DATE: 18 April 2007
 SUBJECT: LO Linx - Addition of Function Delay

- The purpose of this Bulletin is to inform technicians of the added Function Delay to the LO Linx Module.

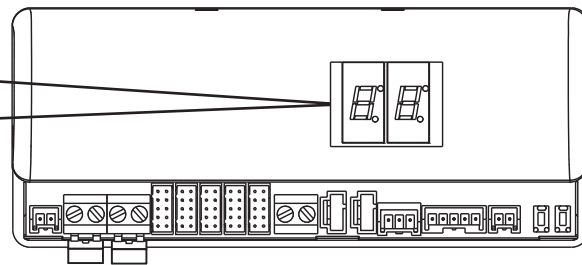
1 Check Function on LO Linx Module

$F_d = 0$ to 10

F_d **Function Delay** - Allows user to adjust extra lockout time if needed for Bodyguard when door is closing. Adjustable from 0 - 10 sec.

NOTE: Only used when Bodyguard comes on before door is completely closed.
